**VIRGINIA ELECTRIC AND POWER COMPANY
RICHMOND, VIRGINIA 23261**

VIRGINIA ELECTRIC AND POWER COMPANY
SURRY INDEPENDENT SPENT FUEL STORAGE INSTALLATION
REQUEST FOR ADDITIONAL INFORMATION
LICENSE RENEWAL APPLICATION
(TAC Nos. L23455 and L23456)

Responses to Request for Additional Information

Surry Power Station Independent Spent Fuel Storage Installation License Renewal Application

SM RAI-3 Figure 3
(Source: Surry ISFSI Technical Specifications Figure 2-5.3)

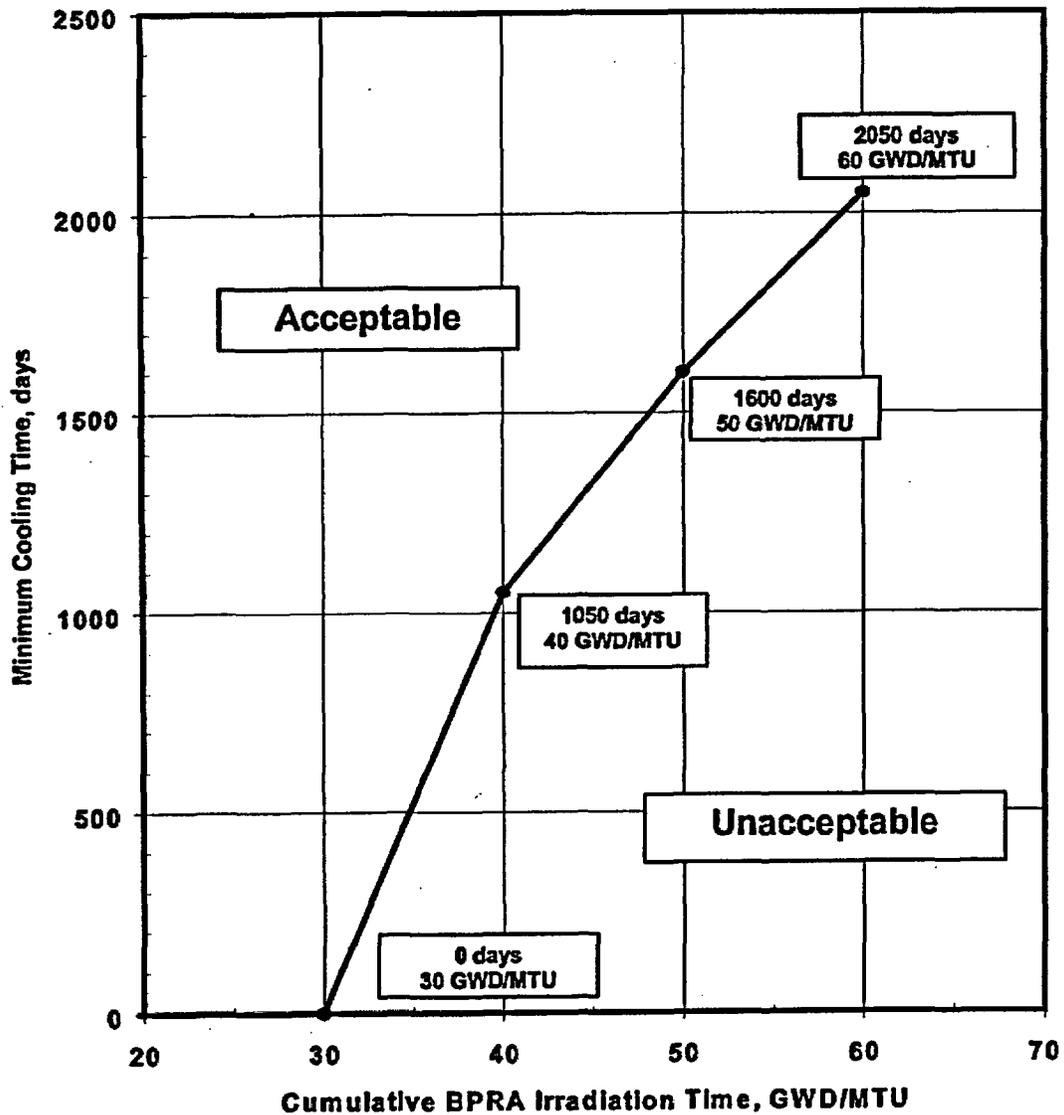
Clarify whether the casks loaded with spent fuel will only be used to store its original contents, or whether they may be reused to store different fuel during the renewed license period. Provide a table of fuel parameters in the currently loaded casks, including the burnup, cooling time, decay heat, fuel type, and fuel condition prior to loading.

Section III.D.8 of the Preliminary Staff Guidance requests that detailed information on the individual fuel assemblies stored in the various casks at a storage facility be provided as part of the license renewal application. Any analyses performed for the individual cask types (criticality, heat loads, etc.) must assume parameters that meet or bound the parameters identified in the facility Technical Specifications. Therefore, the Technical Specifications provide the bounding parameters for fuel inventory currently in storage at Surry. The fuel currently in dry cask storage at Surry met the Technical Specification requirements for burnup, cooling time, decay heat, fuel type, and fuel condition at the time of loading into the respective casks. The following tables summarize these Technical Specification requirements for the casks used at Surry.

TN-32 (Source: Surry ISFSI Technical Specifications Table 2-5)	
Fuel Storage Capacity	≤ 32 Intact unconsolidated Fuel Assemblies
Fuel Type	Westinghouse 15 x 15 Standard Westinghouse 15 x 15 Surry Improved Fuel
Initial Enrichment, (U235 w/o)	≤ 4.05
Average Burnup (MWD/MTU)	≤ 45,000
Decay Heat (kW/Assembly)	≤ 1.02
Cooling Time, Years after irradiation	SM RAI-3 Figure 1 (for Fuel Assembly) SM RAI-3 Figure 2 (for Burnable Poison Rod Assembly, BPRA) SM RAI-3 Figure 3 (for Thimble Plug Device, TPD)
